THE MULBERRY HOUSE SCHOOL, SHOOT UP HILL, LONDON NW2 3XL

B: PROPOSED AMENDMENTS TO PLANNING PERMISSION NO. 2015/5184/P

Amended Report to the Planning Officer: JOHN DIVER

26 September 2016 (following the original report of 20 May 2016 to the previous Planning Officer)

Proposed Elevation B with three small square transparent vision panels in the translucent glazing on Minster Road (MUL-A(0)C18)

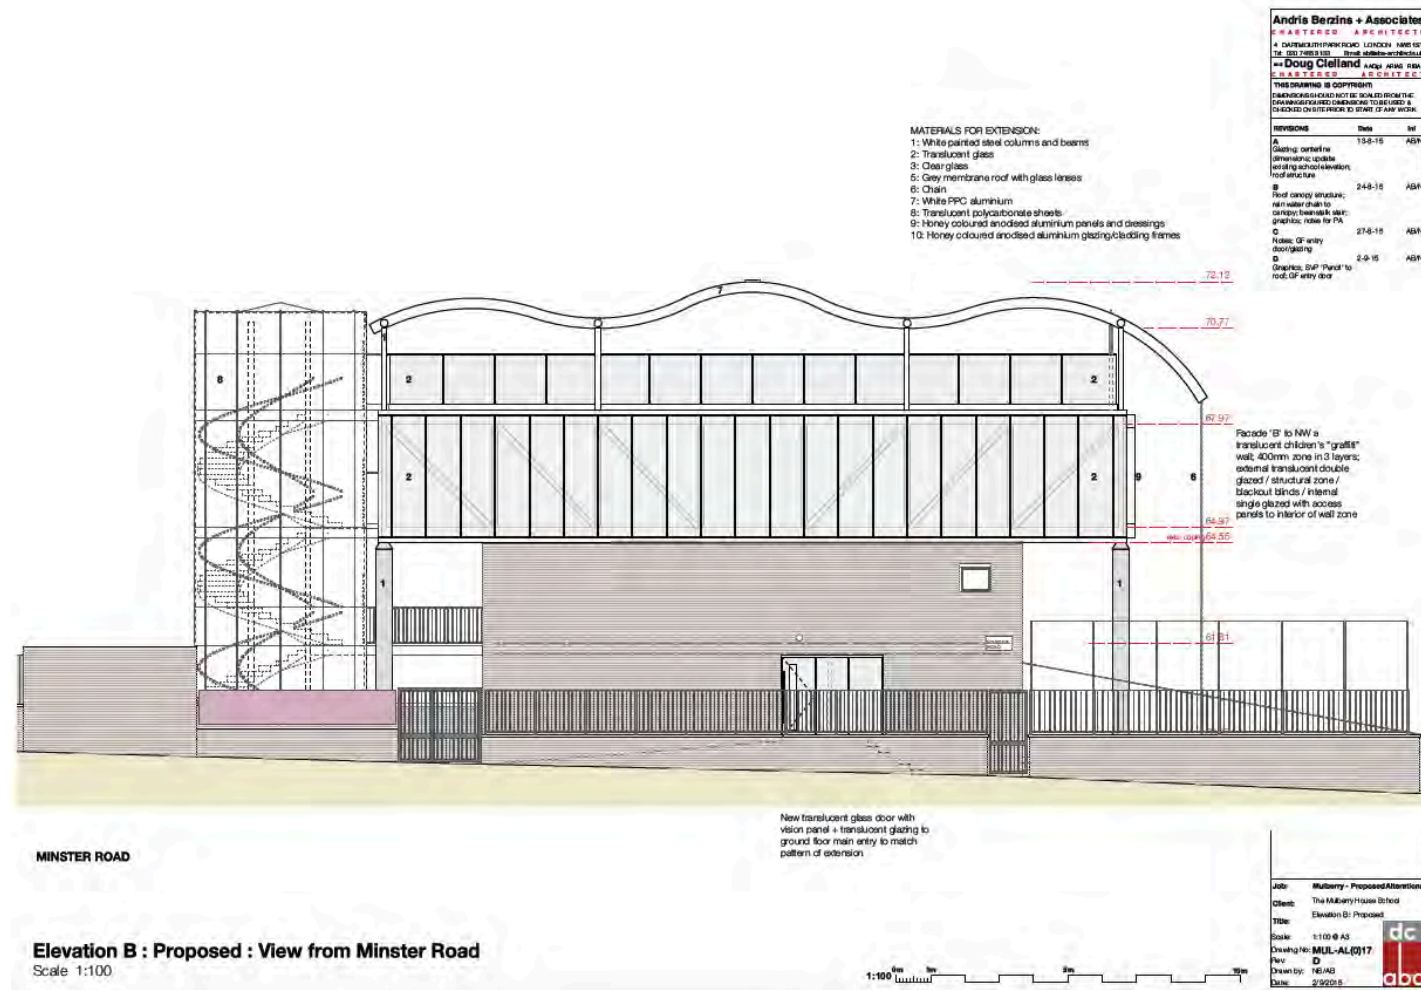
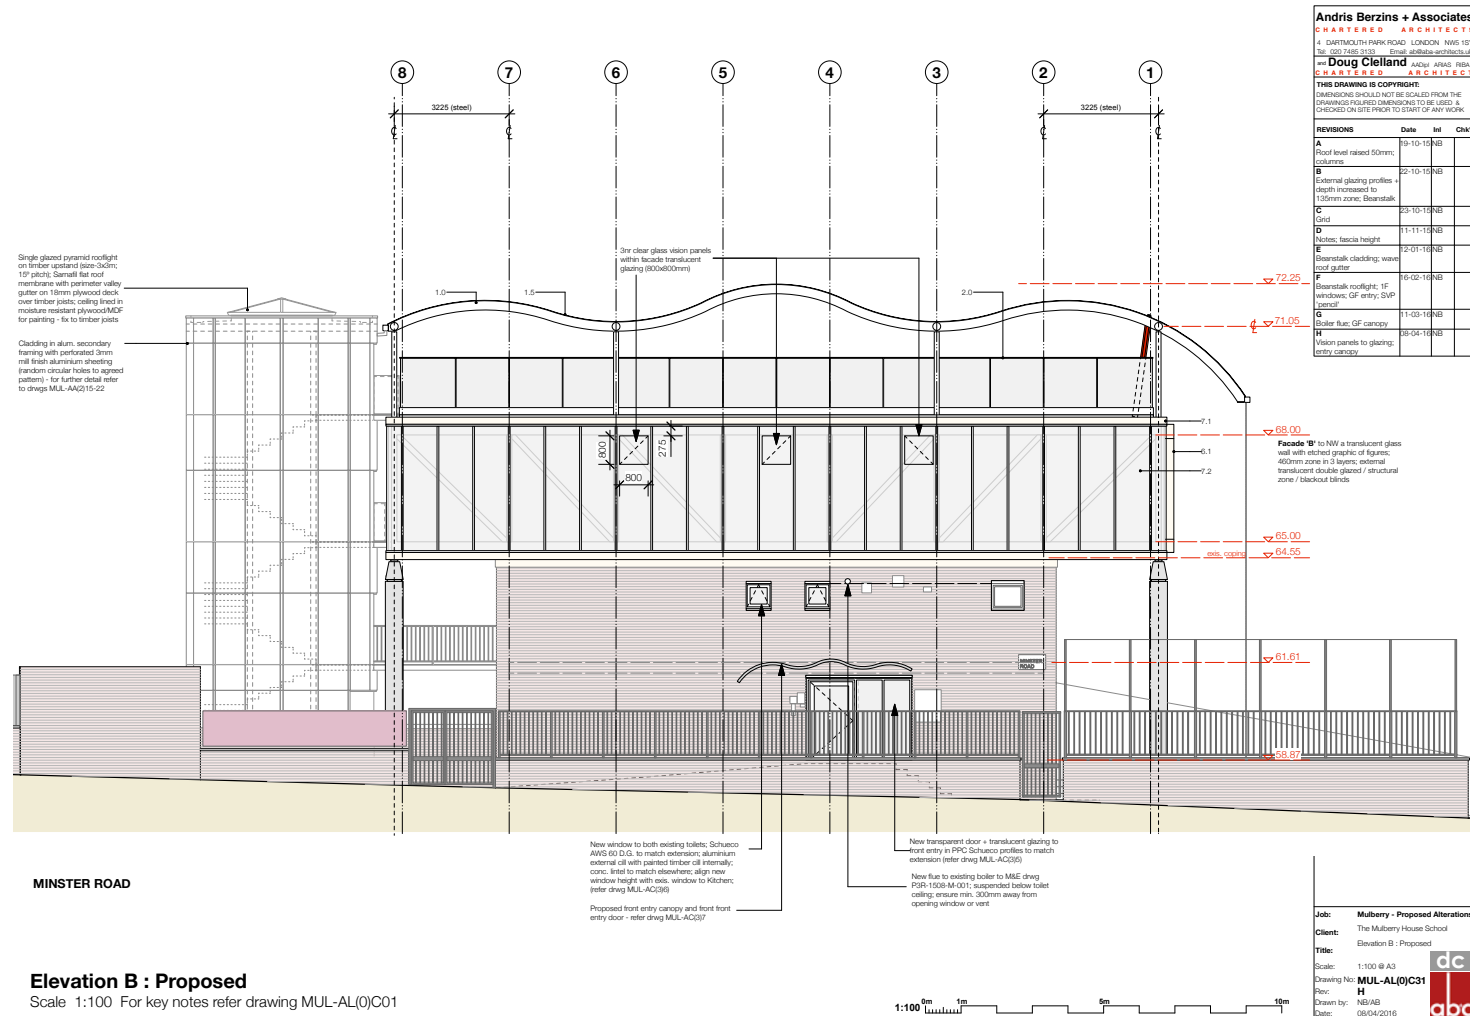
7 Three small transparent vision panels in the translucent glazing on Minster Road

It is good practice that inhabitants of a building have orientation to the external environment. While the new classrooms facing the front and the rear of the extension have both transparent and translucent glazing, the classroom in the centre only has translucent glazing in the permitted design. We therefore propose the introduction of three high-level transparent vision panels to provide views of the sky.

Proposed etched window panels – Elevation B on the left (MUL-AL(0)SK1) – and Elevation A on the right (MUL-AL(0)SK2)

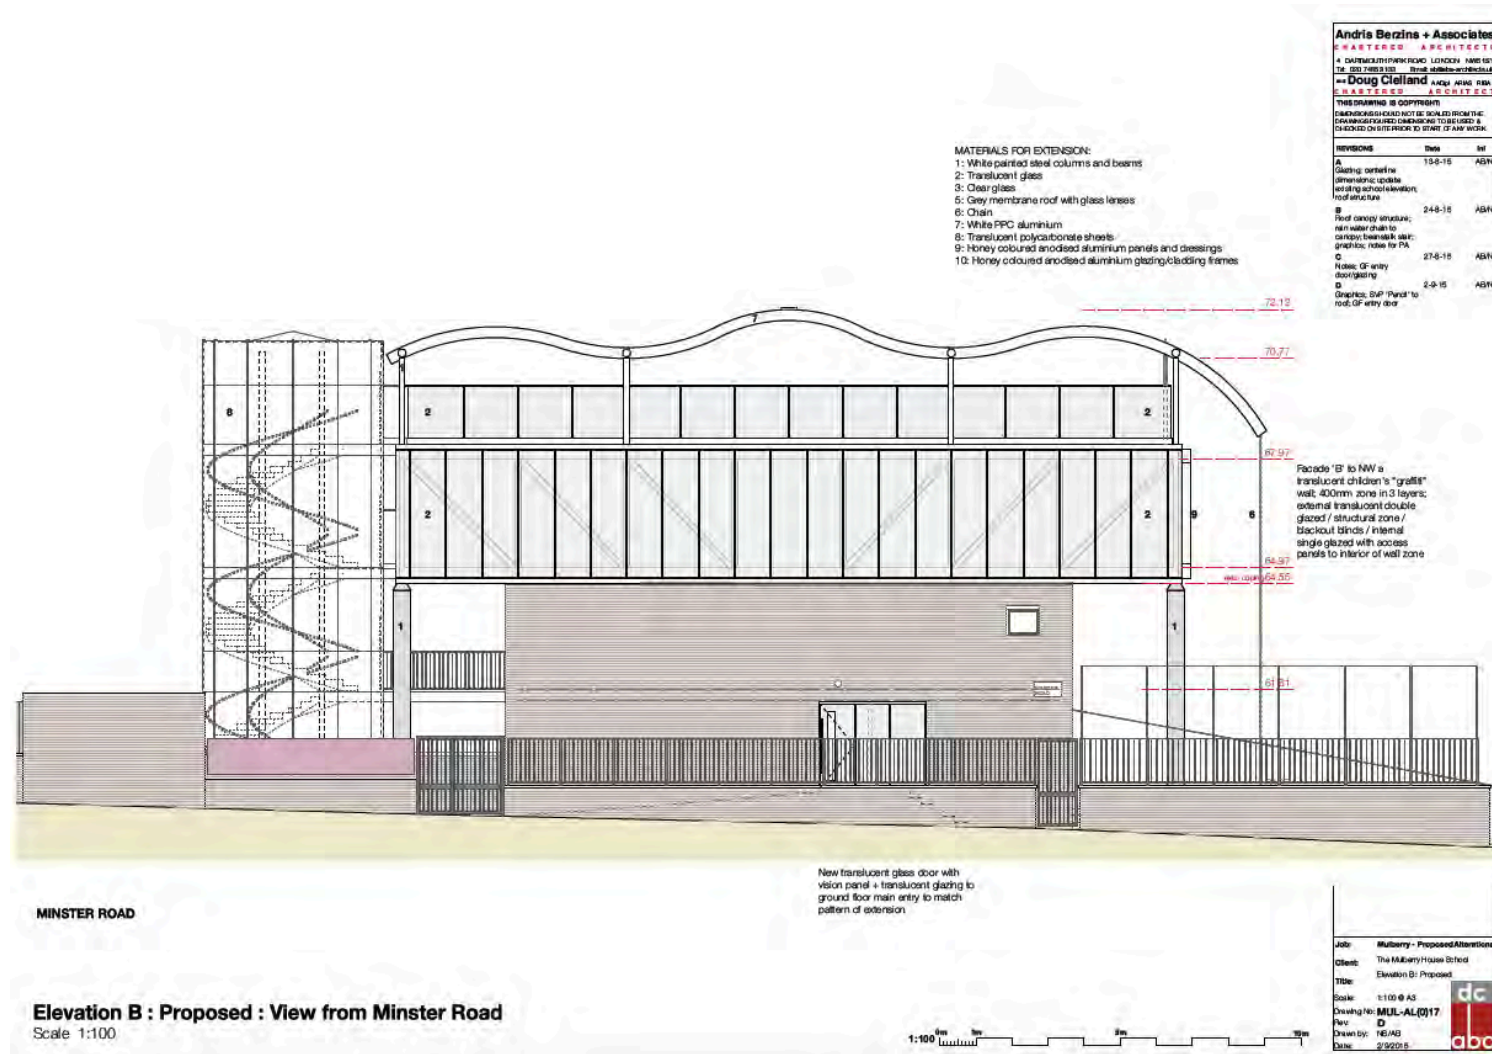
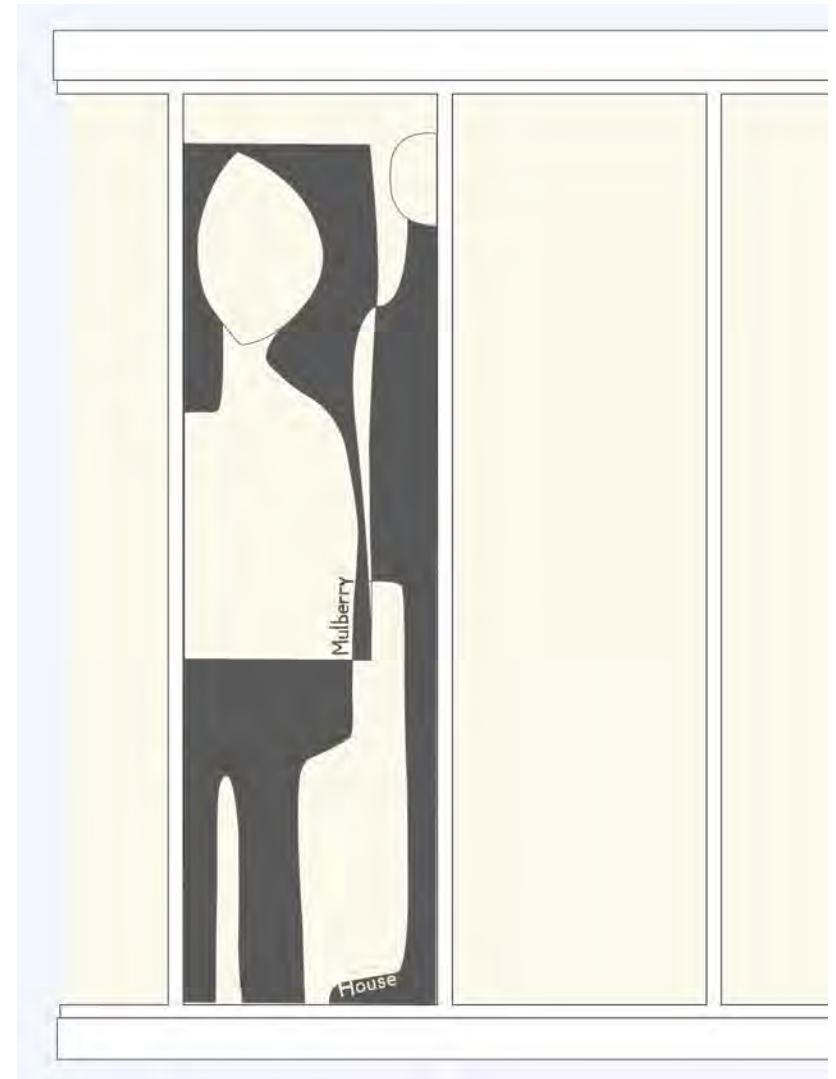
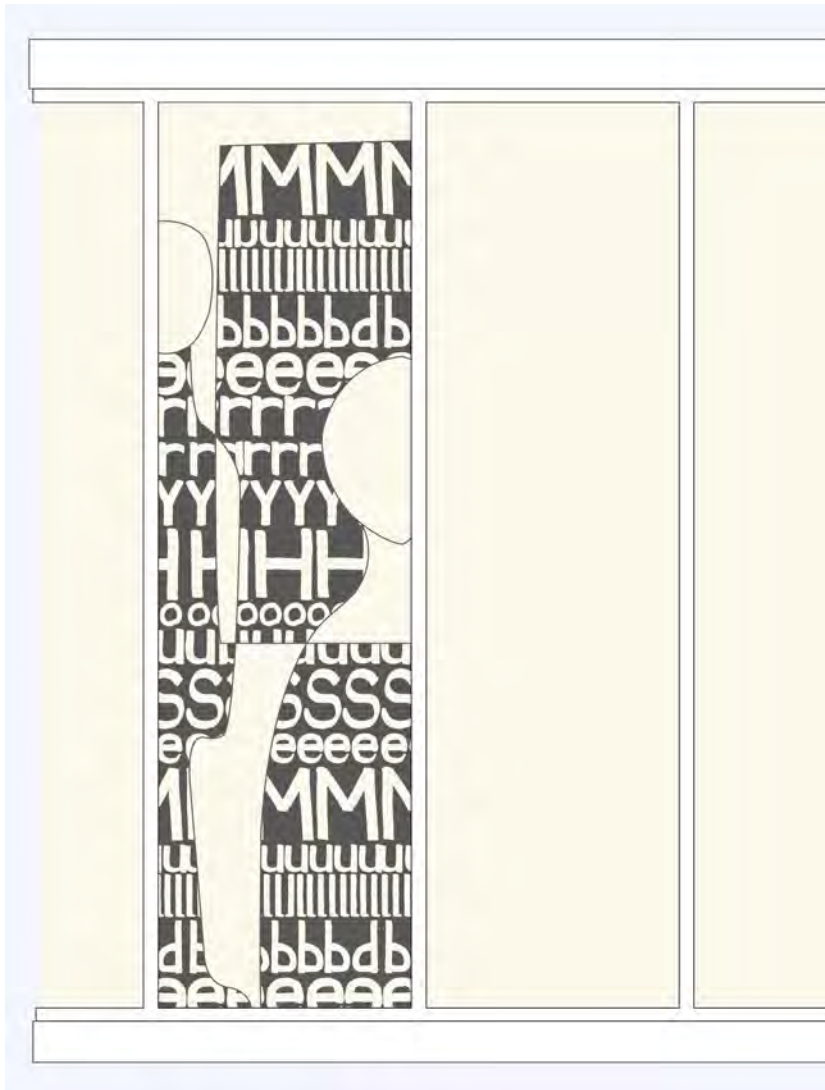
9 Two etched window panels

The client wishes to subtly indicate that this is a school. Two of the translucent glazing panels therefore are proposed to have etched additions to the glass. One is on the furthest left panel of the Minster Road elevation (Elevation B) and the second is on the furthest left panel of the Shoot Up Hill elevation (Elevation A).
